Access Compliance Report

Public Rights-of-Way

(Curb Ramps)

Intersection ID: 30613	Main Street: GOLF_LINKS_DR	Cross Street: PROVIDENCE_RD	Location: SE
ADA ID: 638B2036B46B	Ramp Type: Perp	Initial Pass/Fail: Fail	Overall Compliance: No
Severity Score: 10			
Codes/Mitigation Info/Possible Solution		Field Measurements/Component Compliance

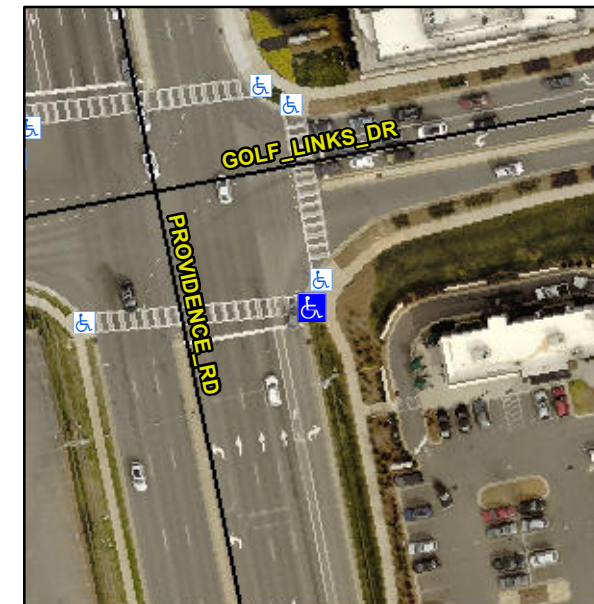
Not Found, R304.5.1, R304.5.3

Compliance	Description	Data	Compliance	Description	Data
N/A	Ramp Length (in)	96.0	Yes	Ramp Slope (%)	7.8
No	Ramp Width (in)	47.5	No	Ramp XSlope (%)	2.9
N/A	Flare Type LT	N/A	N/A	Flare Type RT	N/A
N/A	Flare Slope LT (%)	N/A	N/A	Flare Slope RT (%)	N/A
N/A	Flare Traversable LT?	N/A	N/A	Flare Traversable RT?	N/A
N/A	Landing Length (in)	N/A	N/A	DWS Provided?	N/A
N/A	Landing Width (in)	N/A	N/A	DWS Contrast?	N/A
N/A	Landing Slope (%)	N/A	N/A	DWS Length (in)	N/A
N/A	Landing X Slope (%)	N/A	N/A	DWS Full Width?	N/A
N/A	Landing Curb? (Y/N)	N/A	N/A	DWS Offset (in)	N/A
N/A	Shared Landing?	N/A			
N/A	Gutter Ponding?	N/A	N/A	Gutter Slope (%)	N/A
N/A	Gutter Lip Ht (in)	N/A	N/A	Gutter X Slope (%)	N/A
N/A	Painted X Walk1?	Yes	N/A	Painted X Walk2?	N/A
	X Walk 1 Direction	To W		X Walk 2 Direction	N/A
N/A	X Walk 1 Width (in)	105.0	N/A	X Walk 2 Width (in)	N/A
	X Walk 1 Slope (%)	0.5		X Walk 2 Slope (%)	N/A
	X Walk 1 X Slope (%)	2.4		X Walk 2 X Slope (%)	N/A

Remove & Replace Entire Ramp.
